工務小組委員會在二零零九年一月七日舉行的會議
政府當局需採取跟進行動的事項
項目 PWSC(2008-09)56
49 RG 元朗第 3 區公共圖書館及體育館

title	49 RG	drawn by	LUK KAI SUN	date	JAN 09	drawing no.	size	scale
	PUBLIC LIBRARY & INDOOR RECREATION CENTRE IN AREA 3, YUEN LONG	checked by	KAH WONG	date	JAN 09			
	元朗第3區公共圖書館及體育館	office	ARCHITECTURAL BRANCH

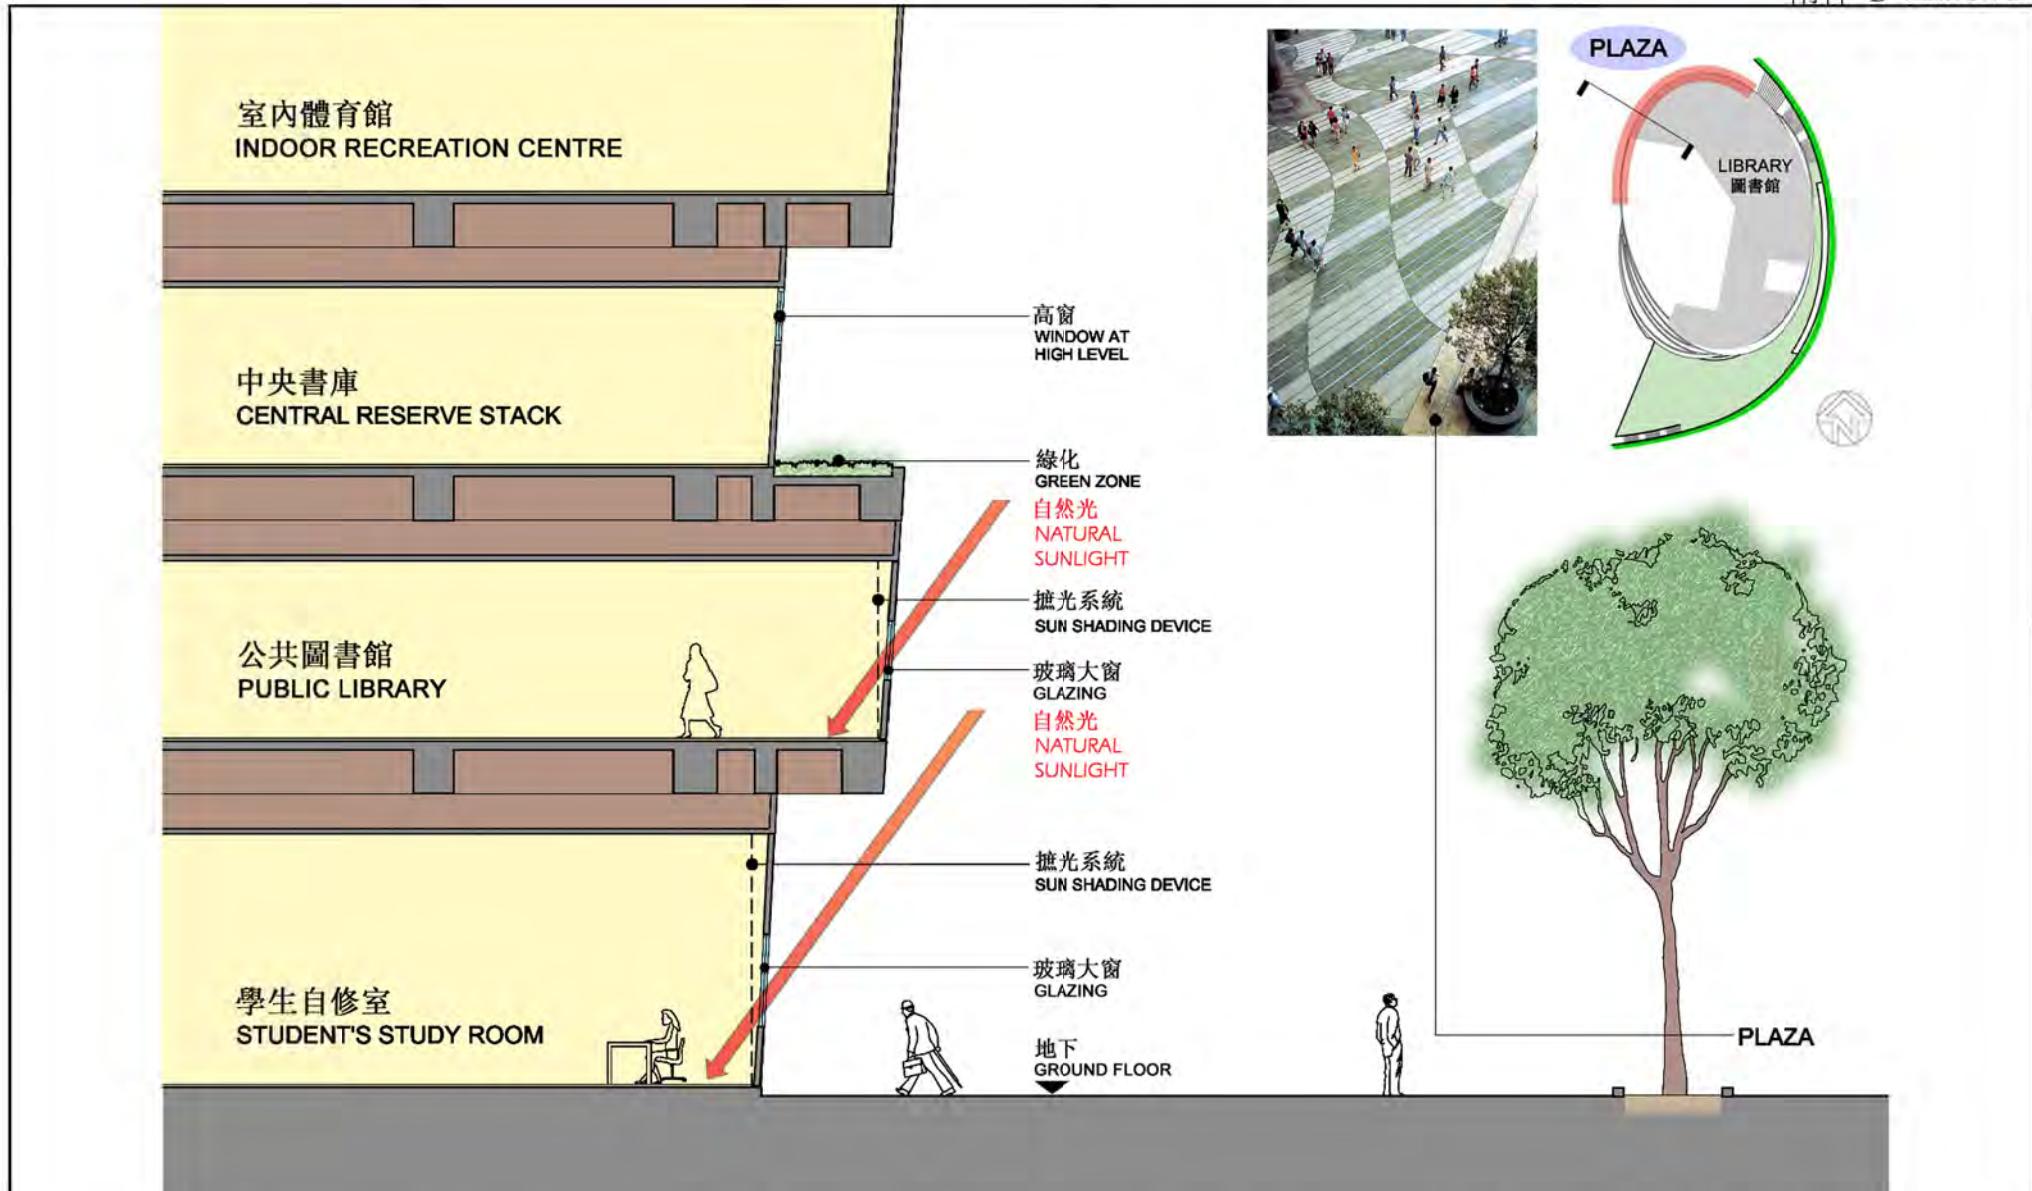
事項 有關劉秀成議員對圖書館是否設有足夠窗戶的關注，並詢問把擬議體育館設於圖書館之上的理由；以及陳偉業議員和甘乃威議員提出為建築物加強綠化措施（包括以垂直種植模式進行綠化）的要求，政府當局會在有關的財務委員會會議舉行前提供進一步資料，當中包括更詳細的平面圖，以供委員參閱。

回應 圖書館的設計已包括設置足夠的窗戶，以便利用天然陽光改善閱讀環境。顯示圖書館窗戶位置的詳細平面圖載於附件 A 和附件 B。

設置擬議體育館的處所不可以有垂直建築結構，而且應設有長跨距上蓋。把體育館設在頂層是較可取的做法，就結構而言亦合乎理想，可達到成本效益。把不向公眾開放的中央書庫設在體育館之下和圖書館之上，可以盡量減低體育館活動可能對圖書館使用者造成的噪音滋擾。
